PAVEMENT SCOPE CLARIFICATION EXHIBIT

ORANGE COUNTY UTILITIES OPERATIONS CENTER
8100 PRESIDENTS DRIVE
ORLANDO, FLORIDA

CONFORMED SET

C-103

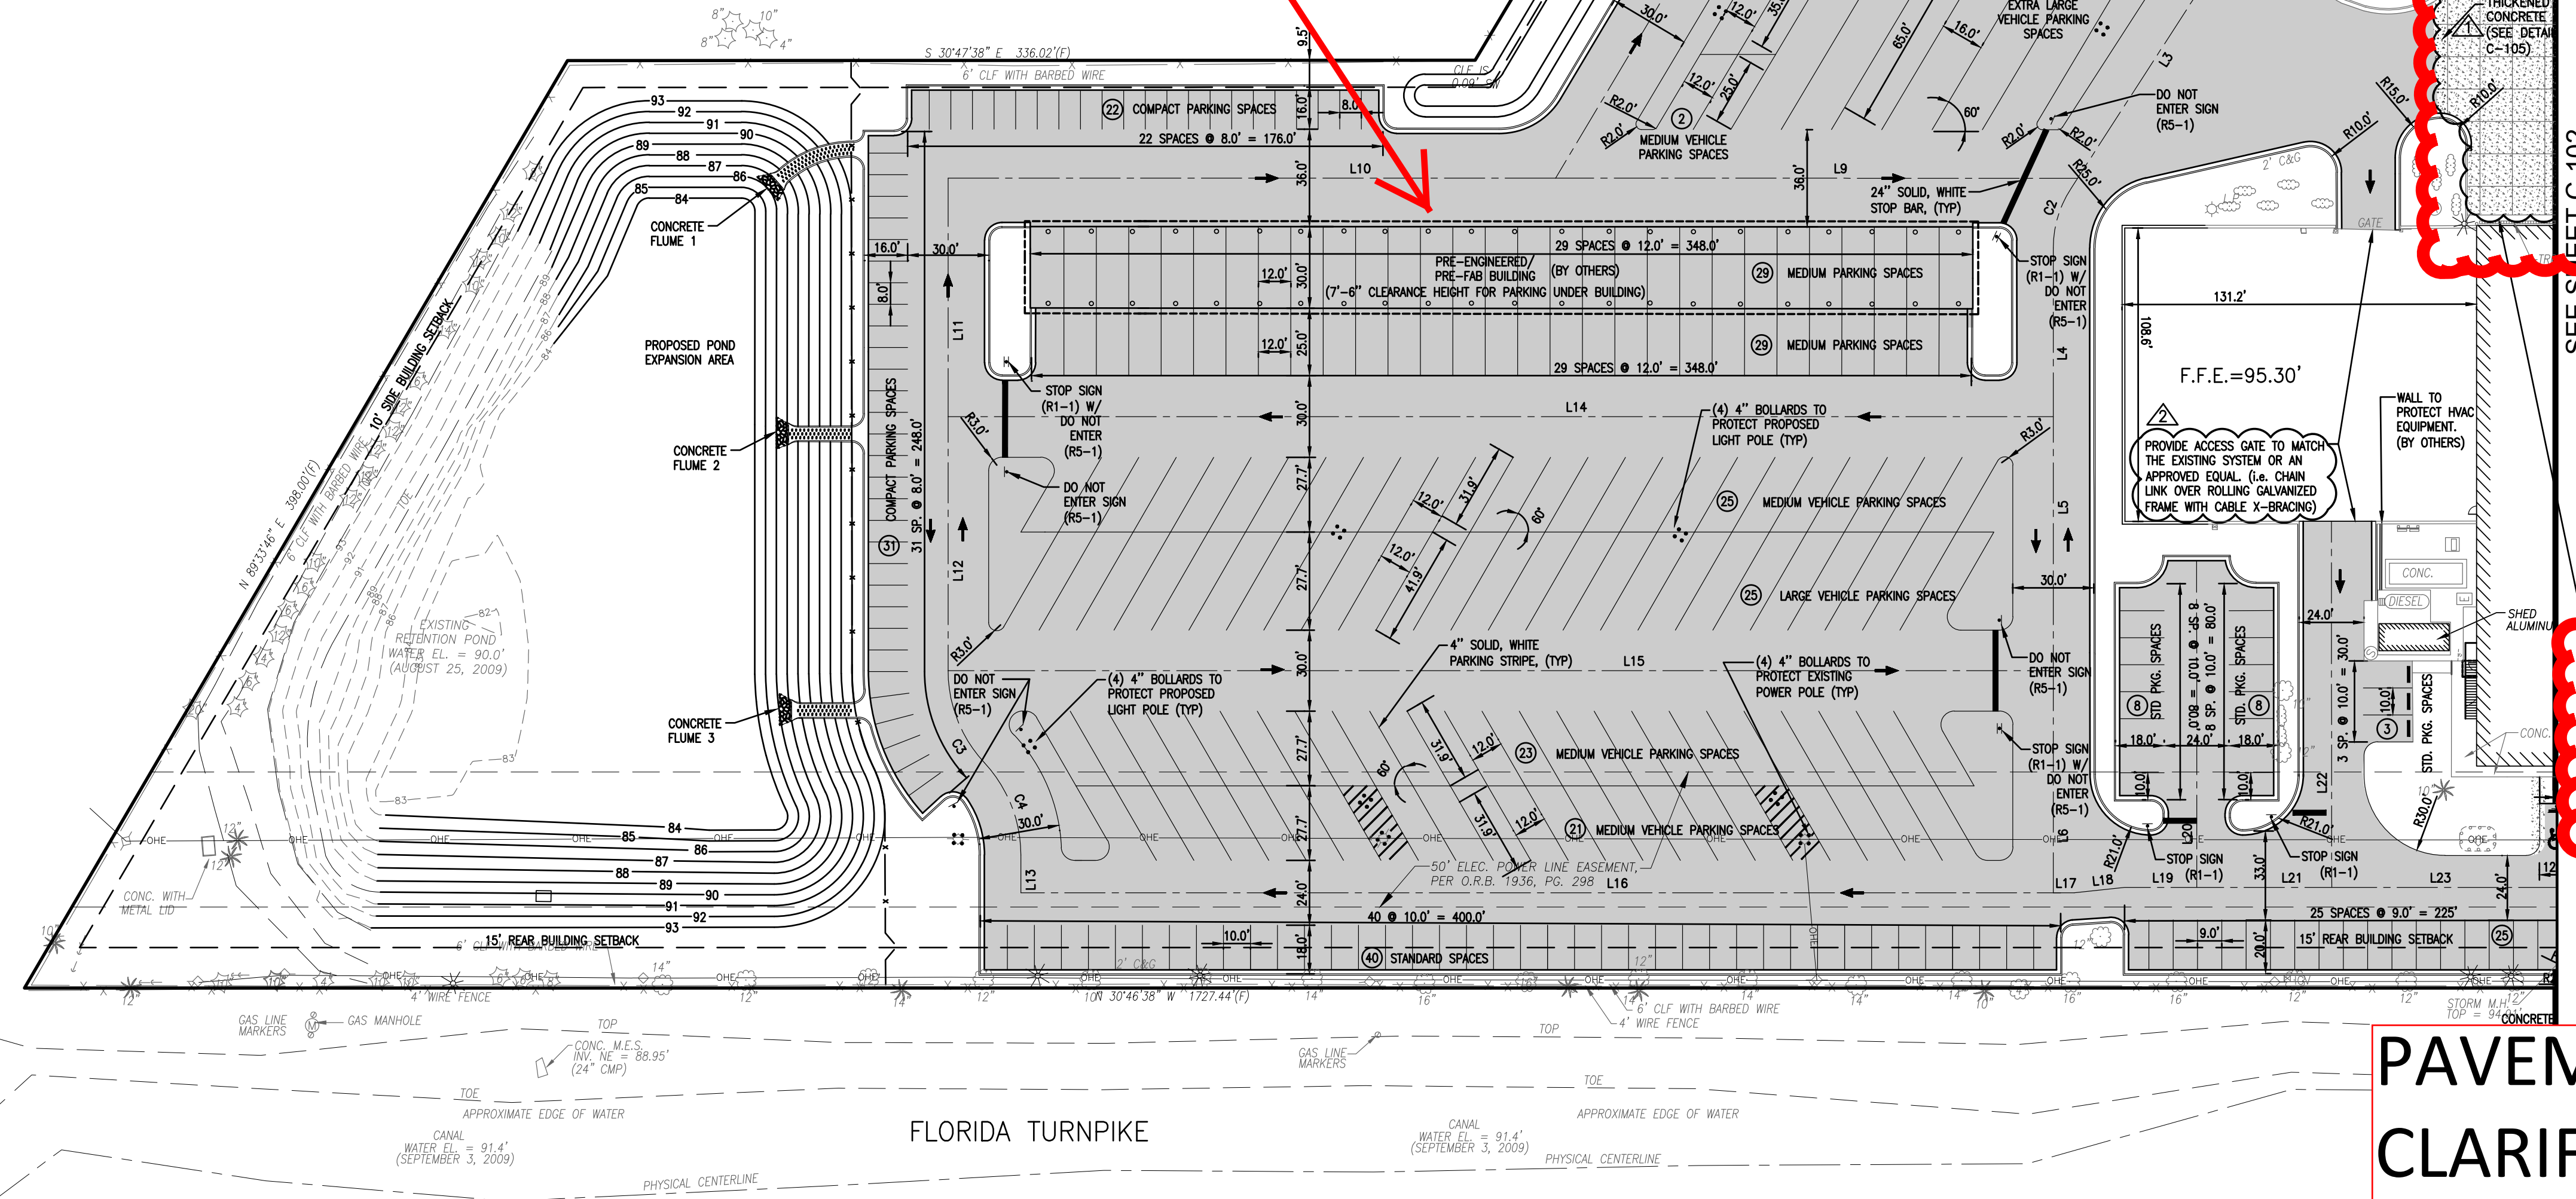
AREA SHOWN IS THE PAVEMENT INCLUDED IN THIS PROJECT. CONSIST OF APPROXIMATELY 41,400 SF OF CONCRETE PAVEMENT. CONCRETE ASSOCIATED WITH NEW FUEL FACILITY AND TRUCK WASH IS ALSO INCLUDED IN THIS PROJECT SCOPE OF WORK. ALL OTHER PAVEMENT SHOWING IS WITHIN A SEPERATE CONTRACT AND SHALL NOT BE INCLUDED IN THIS SCOPE OF WORK.

CONTRACTOR IS RESPONSIBLE FOR PAVEMENT REPLACEMENT AND REPAIR FOR FOUNDATION INSTALLATION AND ANY DAMAGE ASSOCIATED WITH THE CONSTRUCTION OF THE PEMB

ADD SCOPE FOR DEMOLITION OF APPROXIMATELY 41,400 SF OF EXISTING ASPHALT PAVEMENT AND CONSTRUCTION OF APPROXIMATELY 41,400 SF OF NEW CONCRETE PAVEMENT AT LOCATION IMMEDIATELY EAST OF THE EXISTING BUILDING. SEE SHEET C-105 FOR PAVEMENT DETAILS.

SHEET NUMBER
C-104

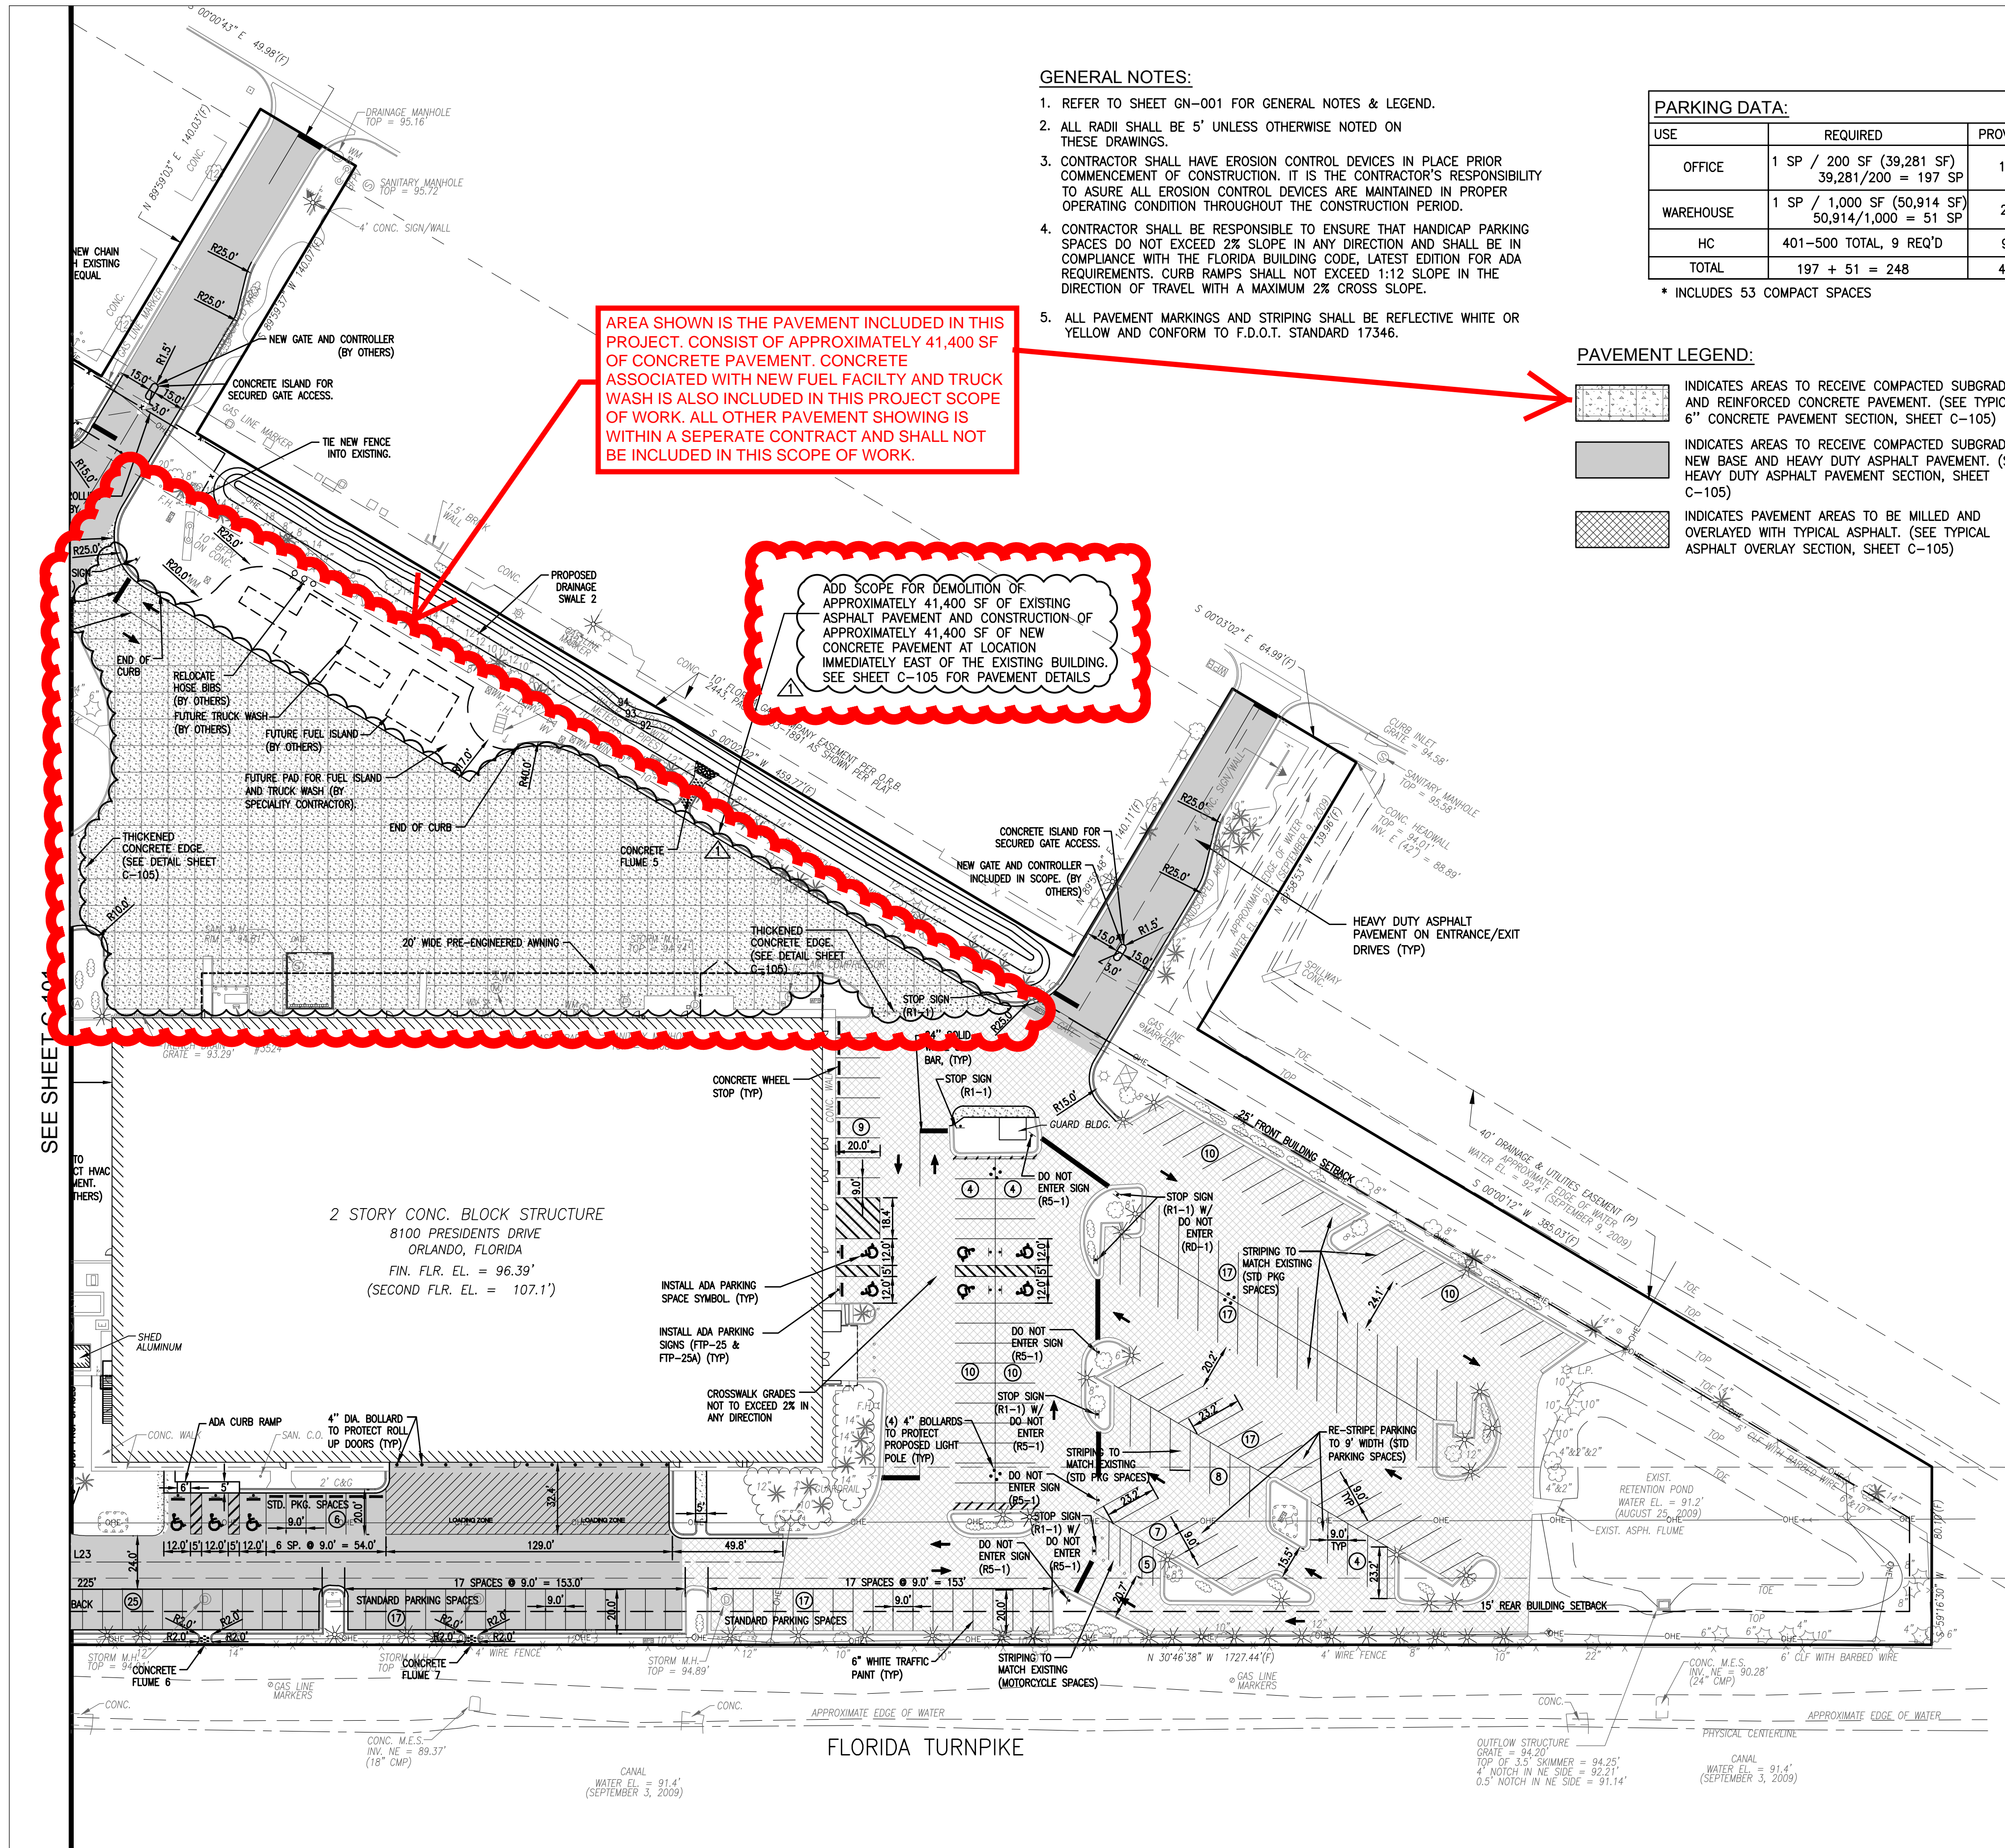
AREA SHOWN IS THE PAVEMENT INCLUDED IN THIS PROJECT. CONSIST OF APPROXIMATELY 41,400 SF OF CONCRETE PAVEMENT. CONCRETE ASSOCIATED WITH NEW FUEL FACILITY AND TRUCK WASH IS ALSO INCLUDED IN THIS PROJECT SCOPE OF WORK. ALL OTHER PAVEMENT SHOWING IS WITHIN A SEPERATE CONTRACT AND SHALL NOT BE INCLUDED IN THIS SCOPE OF WORK.

ADD SCOPE FOR DEMOLITION OF APPROXIMATELY 41,400 SF OF EXISTING ASPHALT PAVEMENT AND CONSTRUCTION OF APPROXIMATELY 41,400 SF OF NEW CONCRETE PAVEMENT AT LOCATION IMMEDIATELY EAST OF THE EXISTING BUILDING. SEE SHEET C-105 FOR PAVEMENT DETAILS

SHEET NUMBER
C-201

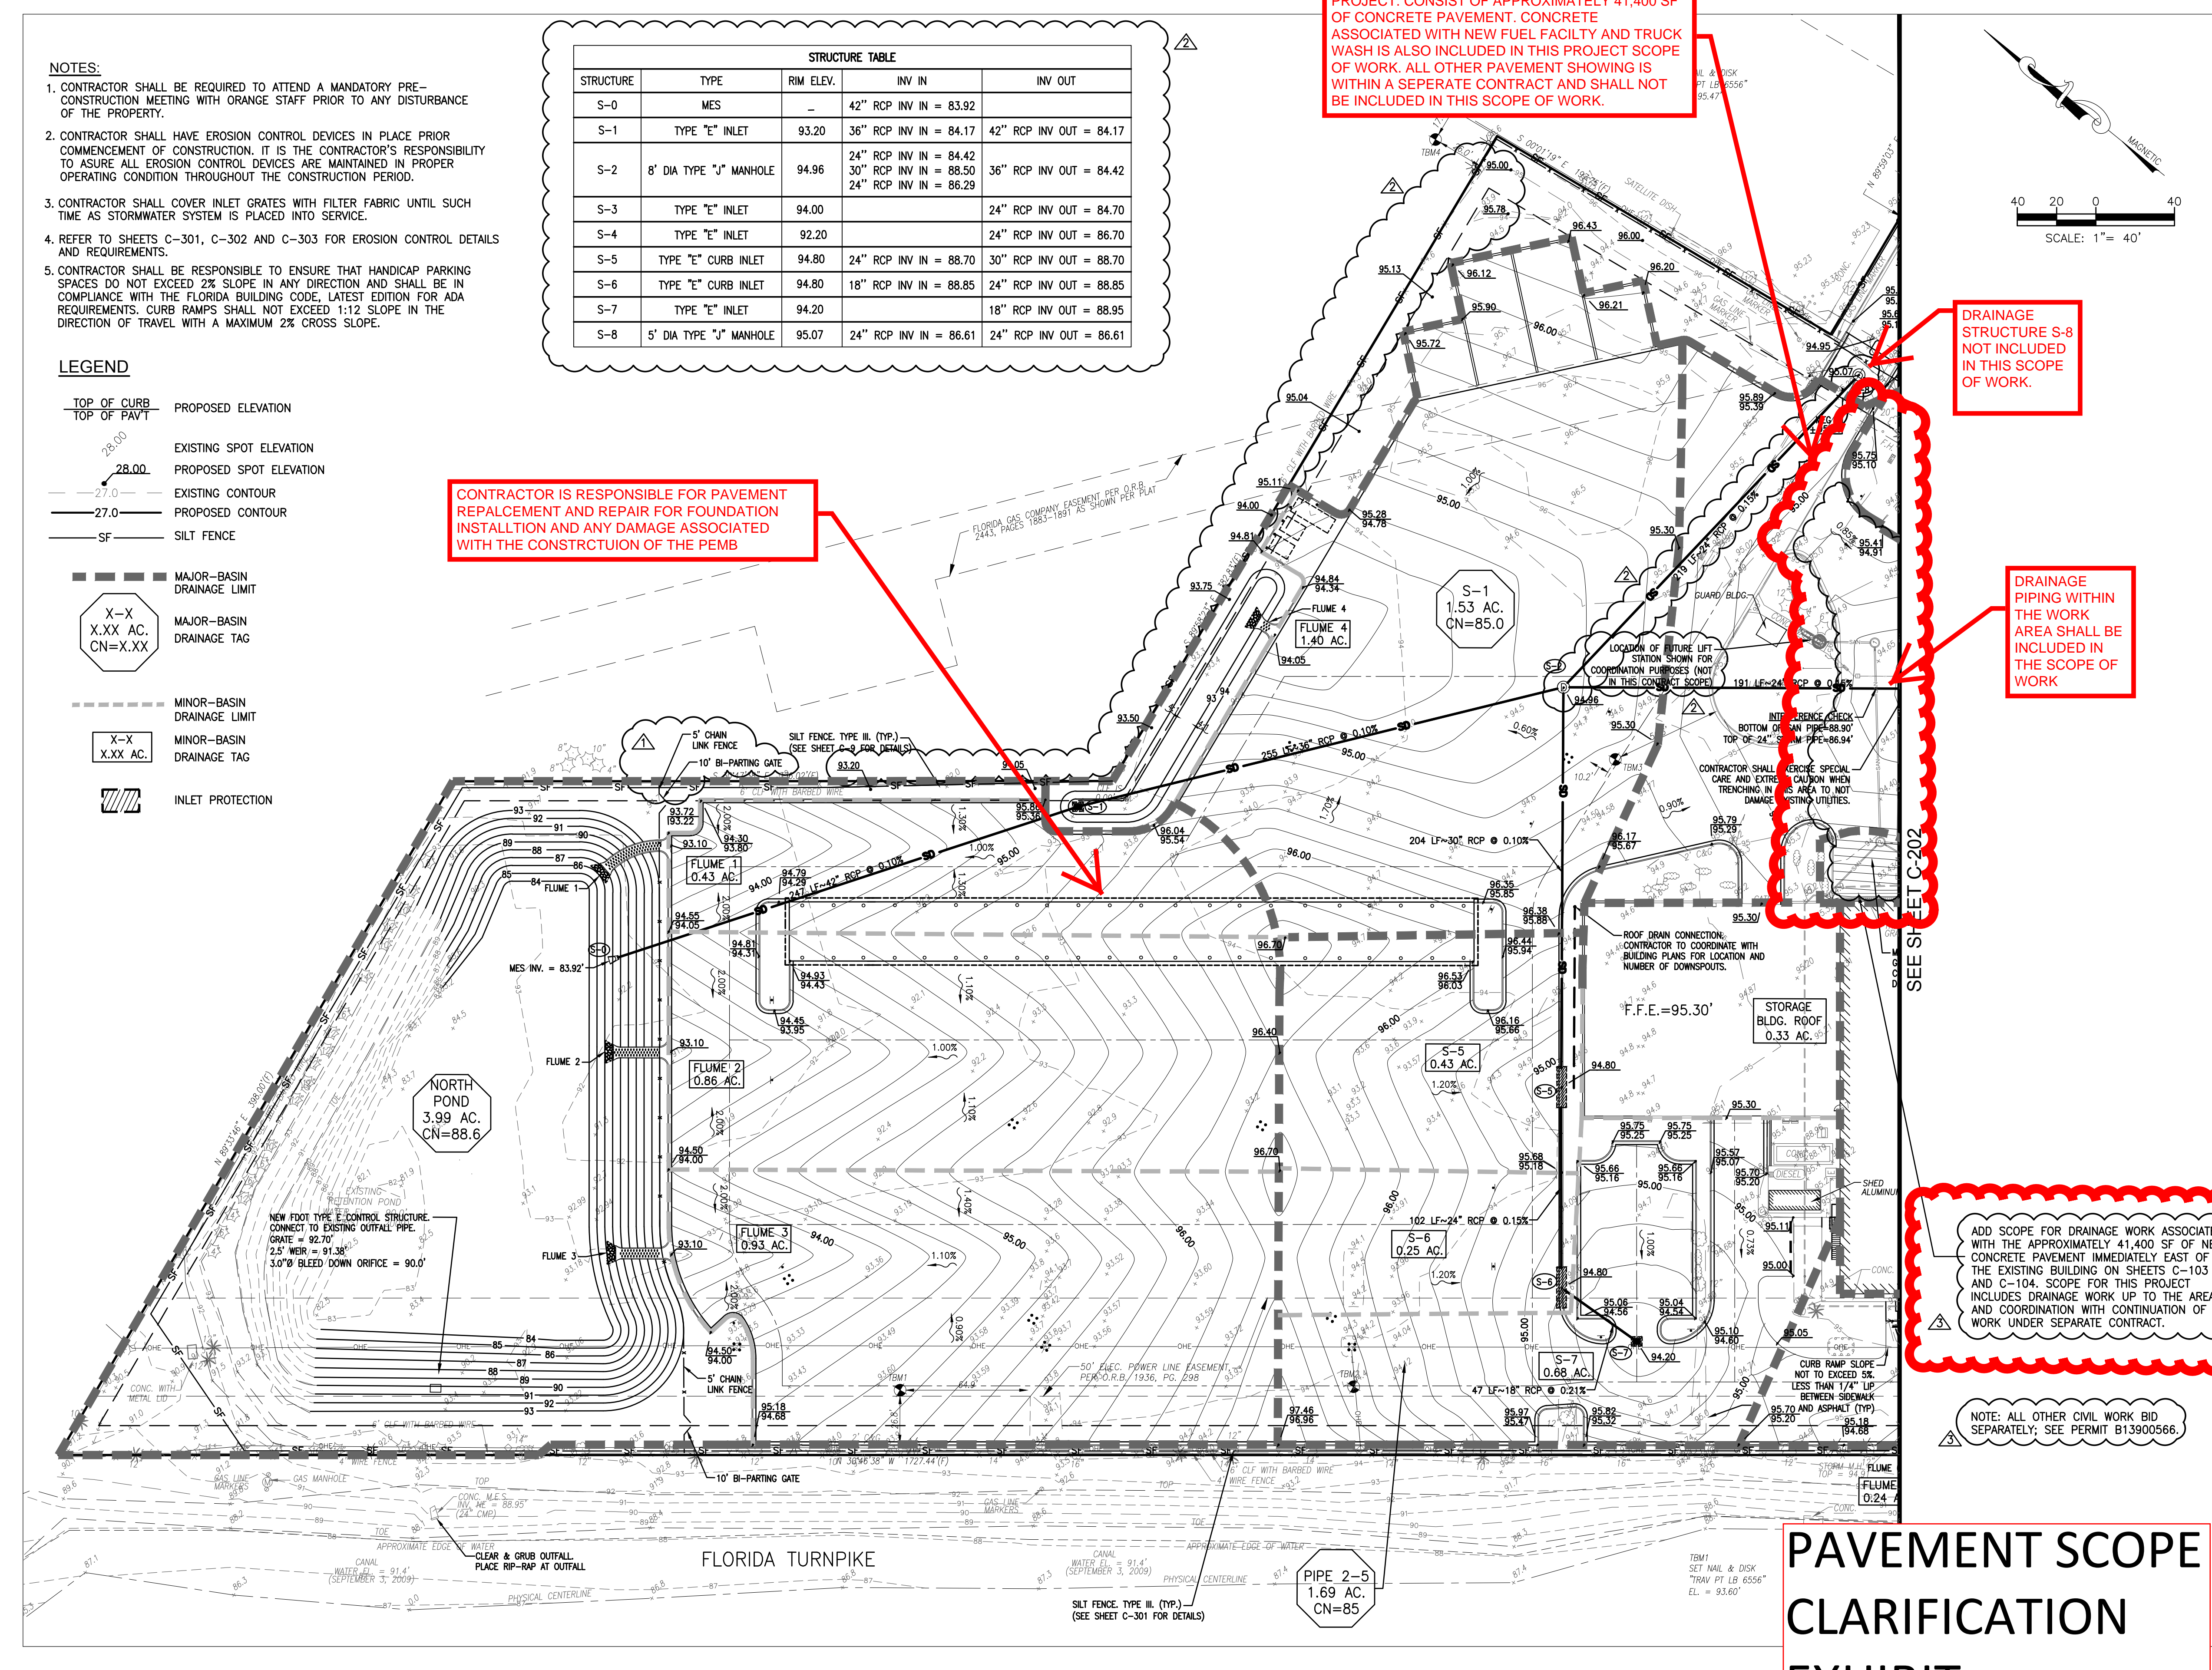
AREA SHOWN IS THE PAVEMENT INCLUDED IN THIS PROJECT. CONSIST OF APPROXIMATELY 41,400 SF OF CONCRETE PAVEMENT. CONCRETE ASSOCIATED WITH NEW FUEL FACILITY AND TRUCK WASH IS ALSO INCLUDED IN THIS PROJECT SCOPE OF WORK. ALL OTHER PAVEMENT SHOWING IS WITHIN A SEPERATE CONTRACT AND SHALL NOT BE INCLUDED IN THIS SCOPE OF WORK.

DRAINAGE STRUCTURE S-8 NOT INCLUDED IN THIS SCOPE OF WORK.

DRAINAGE PIPING WITHIN THE WORK AREA SHALL BE INCLUDED IN THE SCOPE OF WORK

ADD SCOPE FOR DRAINAGE WORK ASSOCIATED WITH THE APPROXIMATELY 41,400 SF OF NEW CONCRETE PAVEMENT IMMEDIATELY EAST OF THE EXISTING BUILDING ON SHEETS C-103 AND C-104. SCOPE FOR THIS PROJECT INCLUDES DRAINAGE WORK UP TO THE AREA AND COORDINATION WITH CONTINUATION OF WORK UNDER SEPERATE CONTRACT.
